AIA Document G701™ – 2017

Change Order

PROJECT: (Name and address)
Williamson County
Animal Shelter Expansion
1855 SE Inner Loop
Georgetown, TX 78626

CHANGE ORDER INFORMATION:
Change Order Number: 003

E.2-3.21

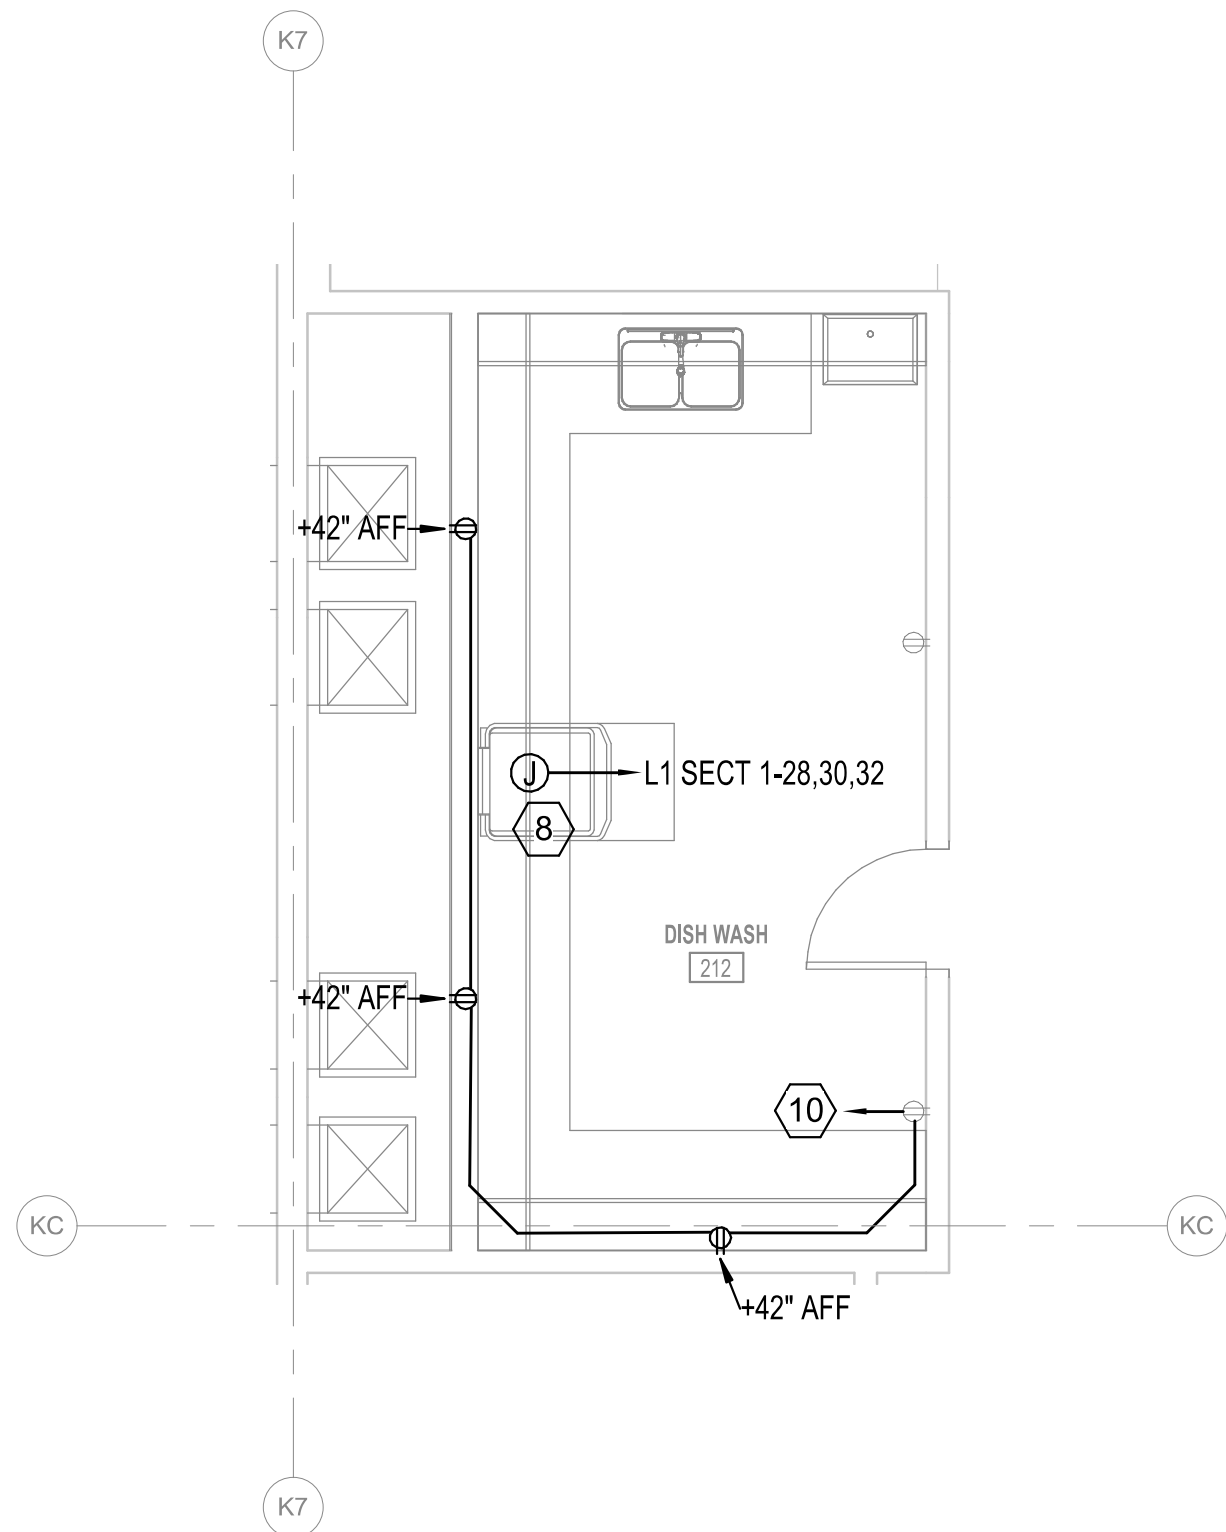
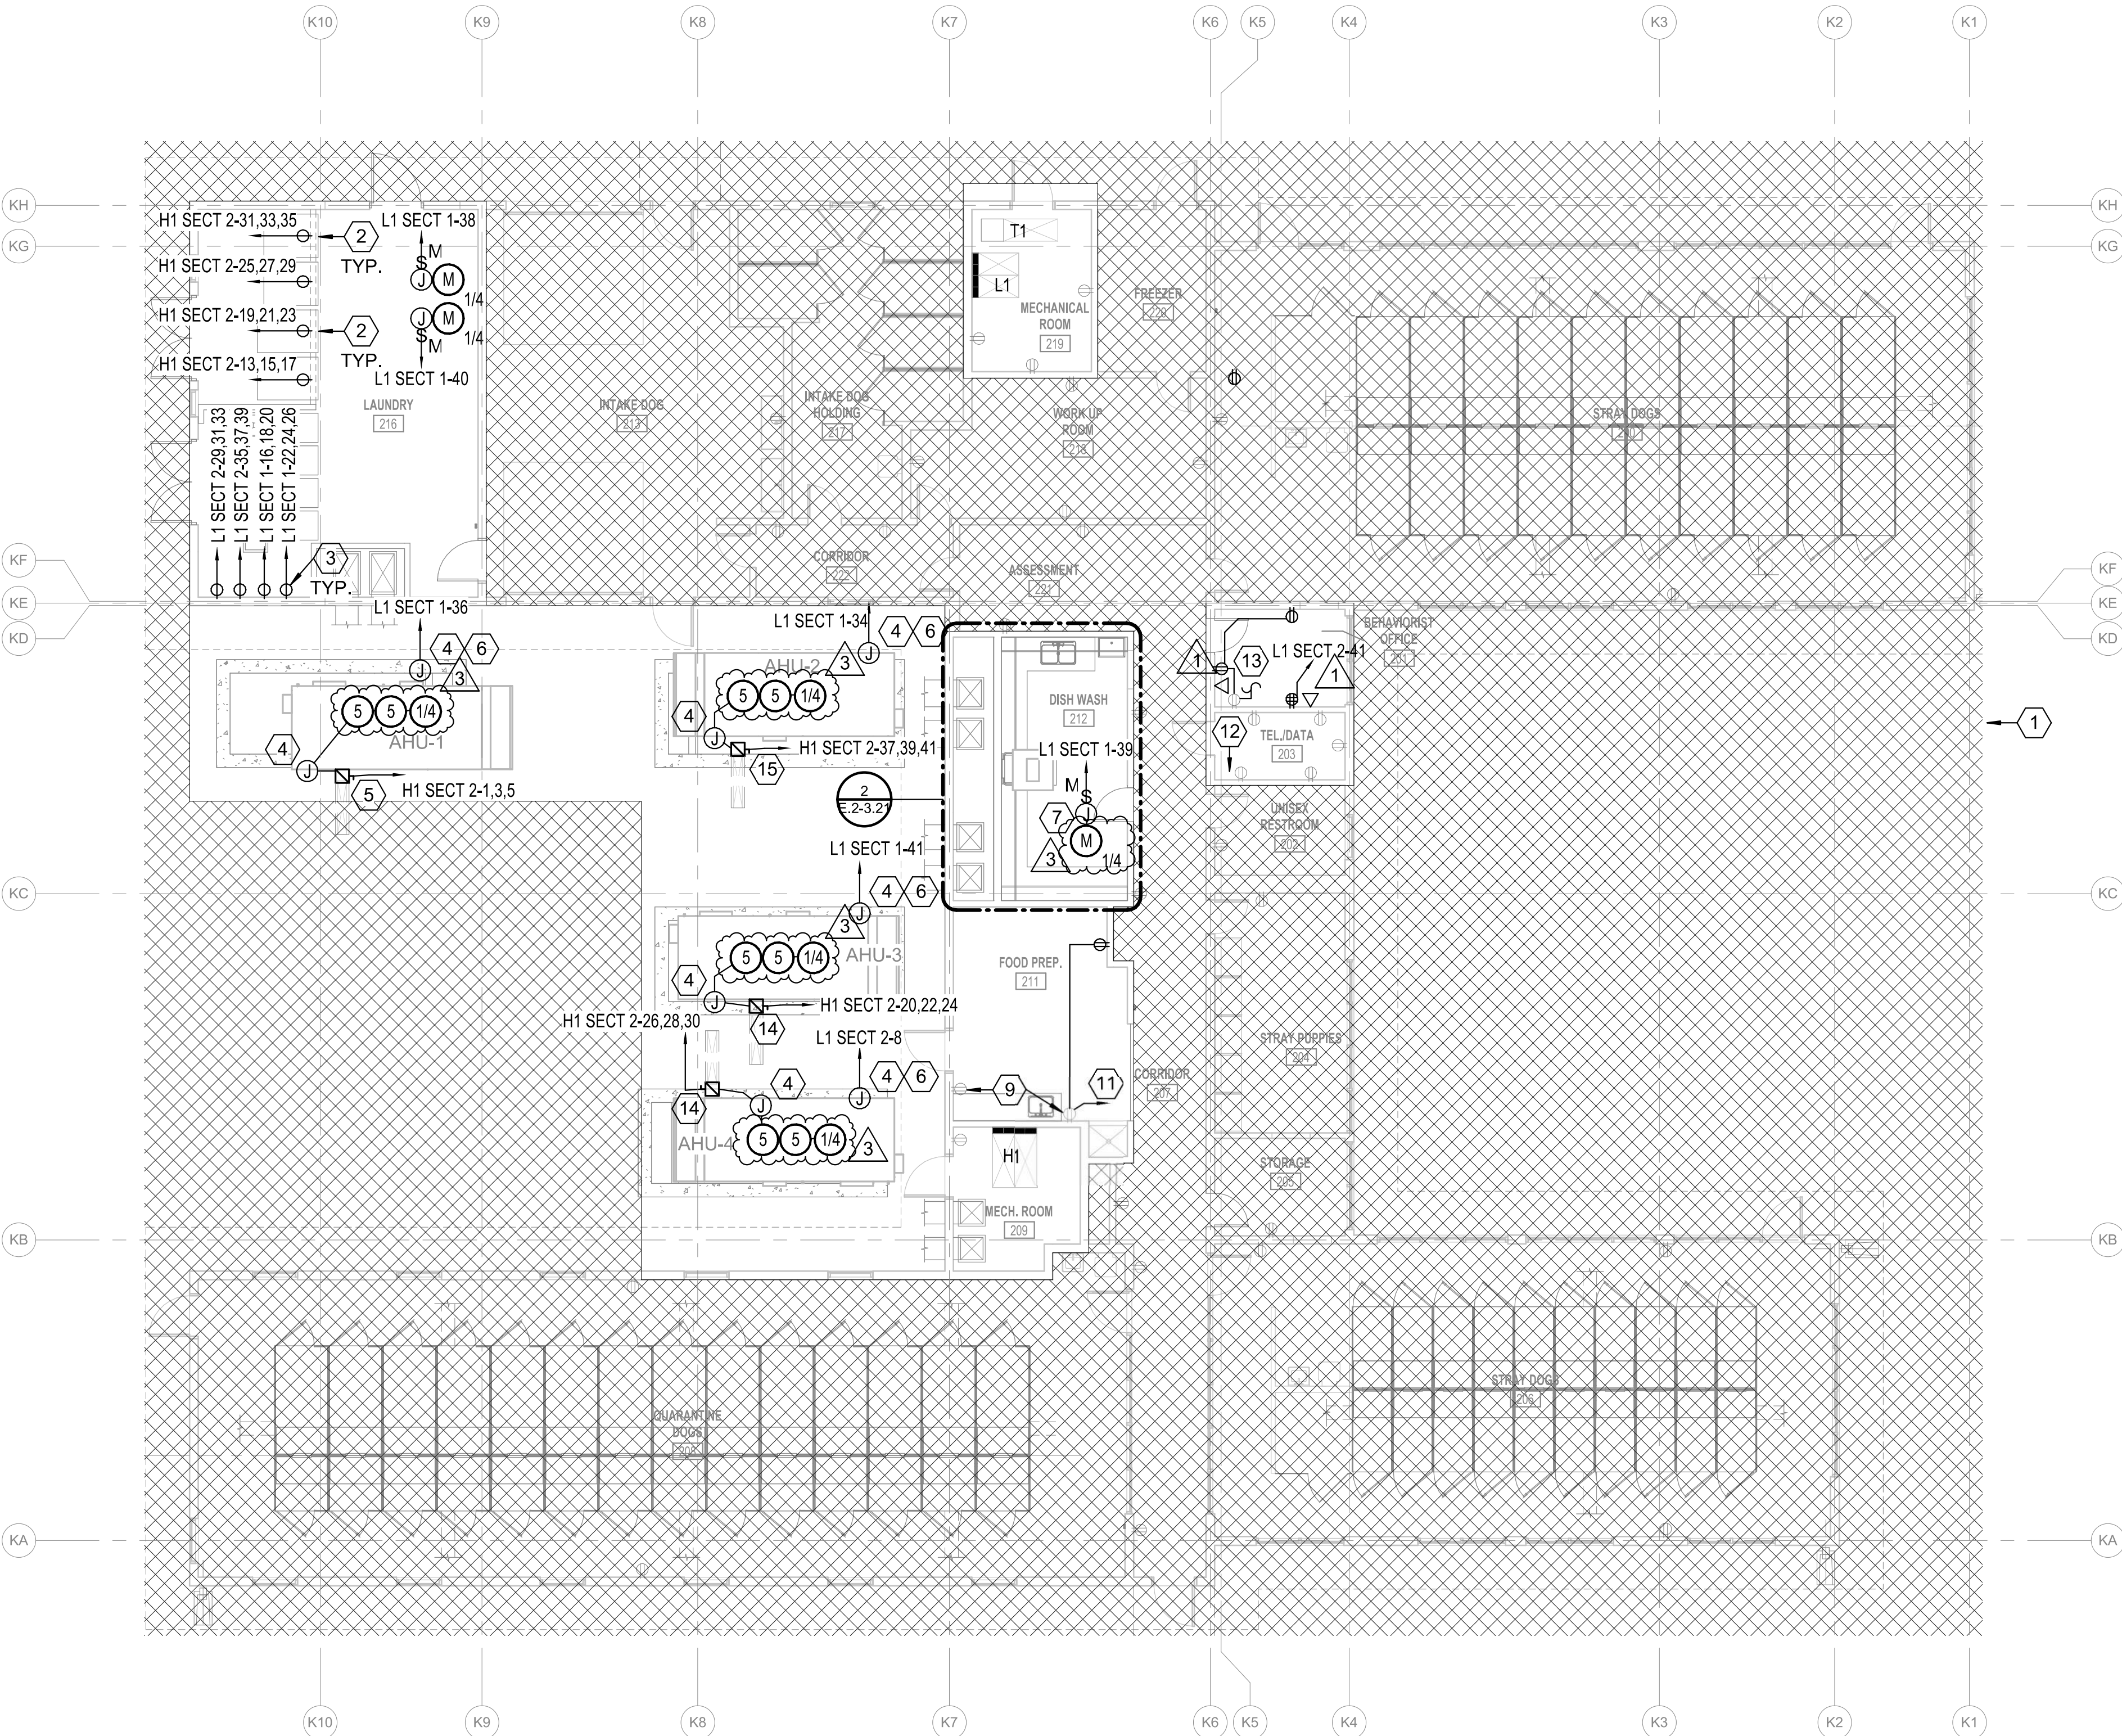
- 5 PROVIDE NEMA 3R, 60A/3P/600V RATED DISCONNECT FUSED AT 50A. UNISTRUT MOUNT DISCONNECT TO EQUIPMENT PAD. COORDINATE LOCATION WITH DIV 23.
- 6 PROVIDE POWER TO MECHANICAL EQUIPMENT AUXILIARIES (LIGHTING, RECEPTACLES, ETC.)
- 7 PROVIDE POWER TO EXHAUST FAN ON ROOF. COORDINATE EXACT LOCATION WITH DIV 23.
- 8 PROVIDE POWER TO COMMERCIAL DISH WASHER.
- 9 REPLACE RECEPTACLE WITH GFCI-PROTECTED RECEPTACLE.
- 10 CONNECT NEW RECEPTACLES TO EXISTING CIRCUIT SERVING DISHWASH 212.

KEYED NOTES - E.3-3.23

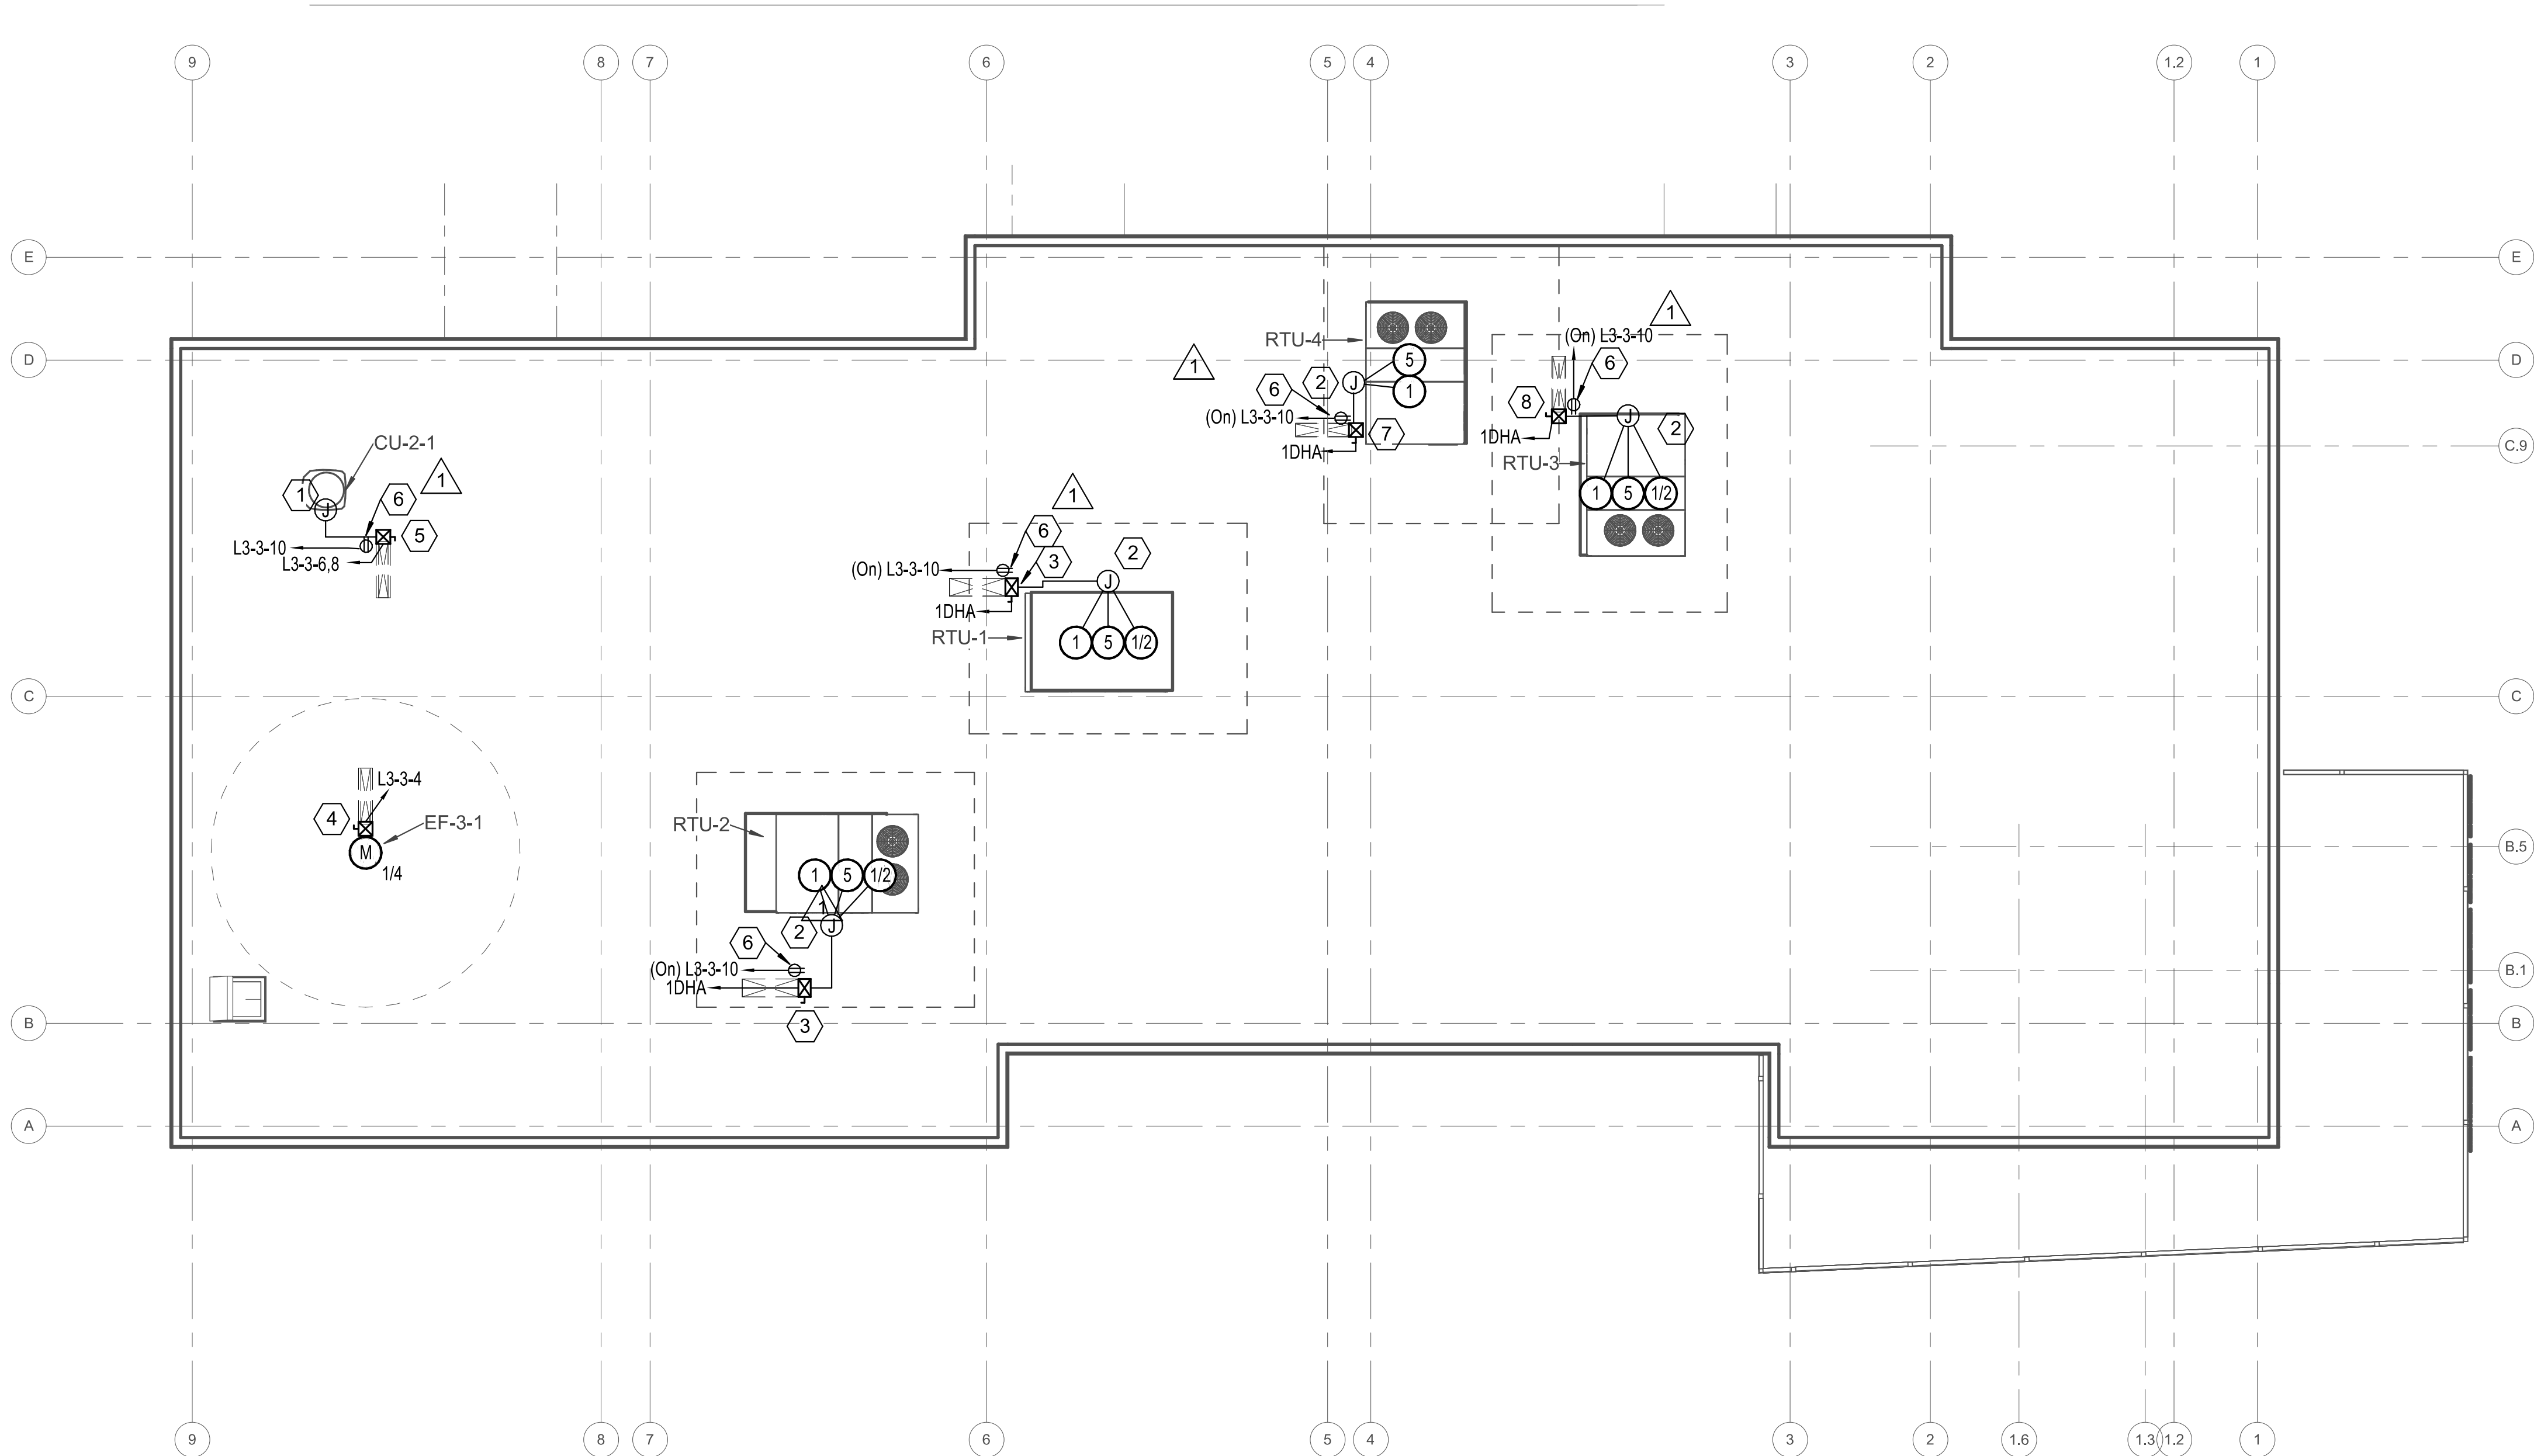
- 5 PROVIDE NEMA 3R, 30A/3P/240V RATED STARTER/DISCONNECT FUSED AT 15A. UNISTRUT MOUNT DISCONNECT TO EQUIPMENT PAD. COORDINATE LOCATION WITH DIV 23.
- 6 PROVIDE GFCI RECEPTACLE WITH WEATHERPROOF WHILE IN USE COVERS MOUNTED TO SAME FRAME AS DISCONNECT.
- 7 PROVIDE NEMA 3R, 60A/3P/600V RATED STARTER/DISCONNECT FUSED AT 60A. UNISTRUT MOUNT DISCONNECT TO EQUIPMENT PAD. COORDINATE LOCATION WITH DIV 23.
- 8 PROVIDE NEMA 3R, 60A/3P/600V RATED STARTER/DISCONNECT FUSED AT 45A. UNISTRUT MOUNT DISCONNECT TO EQUIPMENT PAD. COORDINATE LOCATION WITH DIV 23.
